Docket Item # 7  
BAR CASE #2009-0028

BAR Meeting  
March 18, 2009

**ISSUE:** Alterations  
**APPLICANT:** David and Miriam Olinger  
**LOCATION:** 100 Prince Street  
**ZONE:** RM/Townhouse zone

The applicant is requesting approval of a Certificate of Appropriateness for replacement windows at 100 Prince Street.

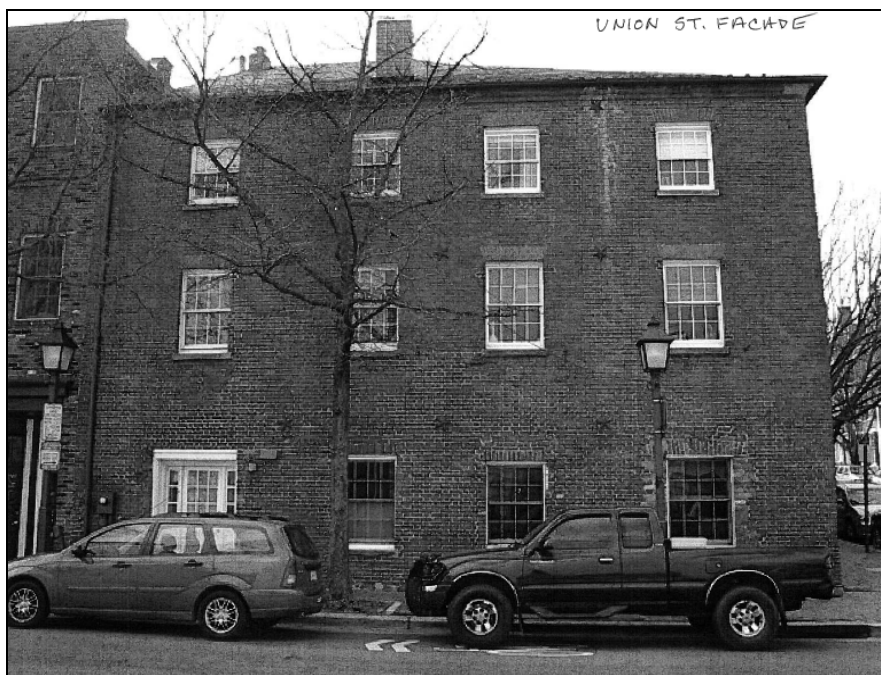
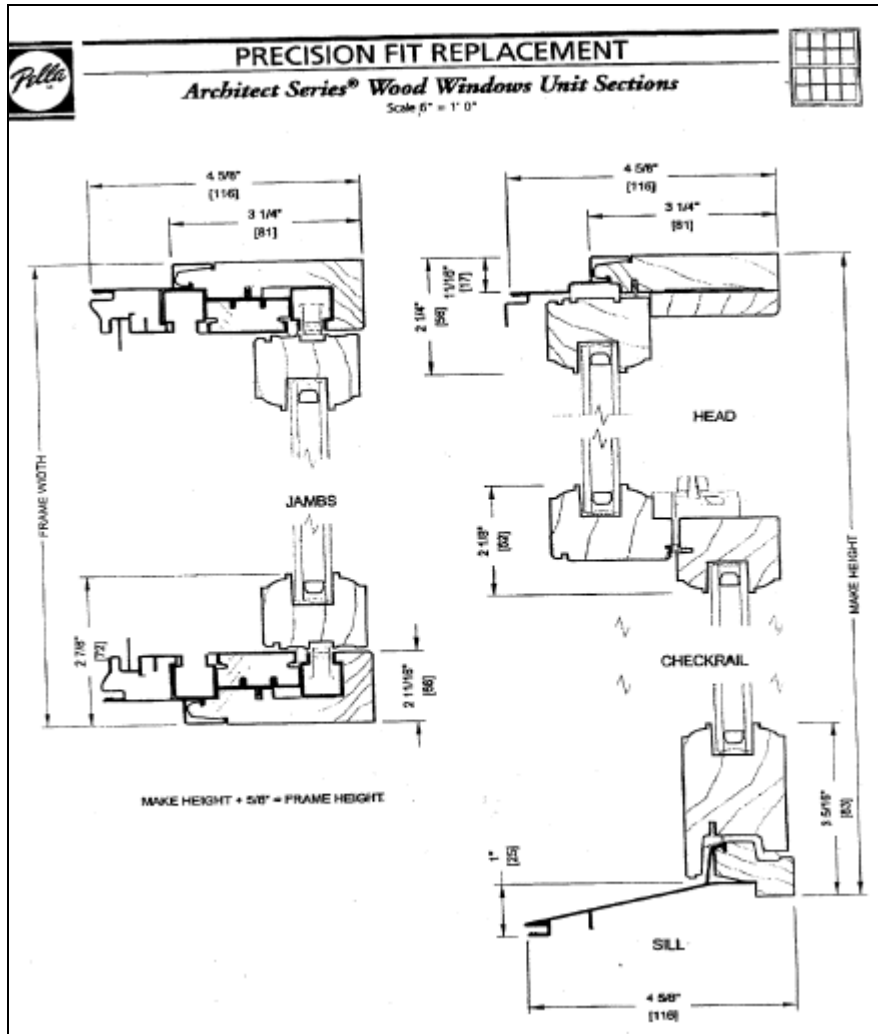
Staff has confirmed that the existing windows are not historic and date from the time of conversion to a residence (1966) or possibly later. Staff has no objection to the removal of the existing windows. However, Staff finds the installation of double-insulated, simulated divided light windows on an eighteenth-century building to be inappropriate. Further, the location of the building, at the corner of Prince and South Union streets, is highly visible. While double-insulated, simulated divided light windows have been approved by the Board, they are generally on rear elevations or new construction, or on non-historic buildings.

Staff finds that the current submission request is not consistent with *Design Guidelines*. Should the applicant wish to install single-glazed, true divided light wood windows, with interior or exterior storm windows, Staff can administratively approve the request.

**IV. STAFF RECOMMENDATION:** Staff recommends denial of the application as submitted.
